SUNDRY NOTICES AND REPORTS ON WELLS

8. Well Name and No.
WEST SHUGART 19 FED 29. API Well No.
30-015-30780-00-S110. Field and Pool or Exploratory Area
SHUGART11. County or Parish, State
EDDY COUNTY, NM

** BLM REVISED ** BLM REVISED ** BLM REVISED ** BLM REVISED ** BLM REVISED **

**Permanent Abandonment of Federal Wells
Conditions of Approval (LPC Habitat)**

PROPOSED WELLBORE

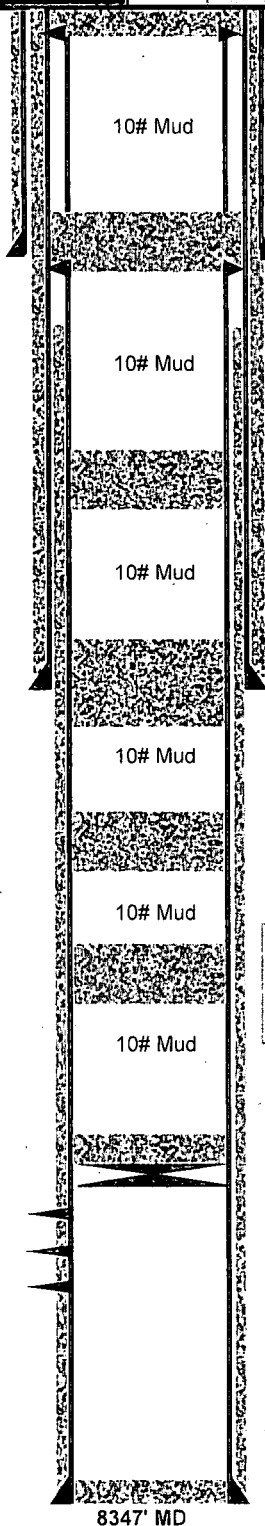
Proposed:
 1. Perf @ 140'.
 2. Squeeze Cl C from 140' to surface.
 3. Cut WH off 3' BGL, set dry hole marker.

Proposed:
 1. Perf at 880'.
 2. Squeeze 25 sx Cl C from 880'-780'. WOC & tag.
 (Shoe @ 830')

Proposed:
 Spot 25 sx Cl C from 1975'-1725'. WOC & tag.
 (Top Yates @ 1919')

Proposed:
 Spot 25 sx Cl C from 2900'-2650'. WOC & tag.
 (Shoe @ 2828')

Proposed:
 Spot 25 sx Cl C from 4350'-4100'.
 (Top Delaware @ 4324')

Proposed:
 Spot 25 sx Cl C from 5750'-5500'.
 (Top Bone Spring @ 5734')

Proposed:
 1. Set CIBP @ 8025'. Tag. Circ 10# salt gel.
 2. Spot 25 sx Cl H from 8025'-7825'.
 (Perfs at @ 8088')
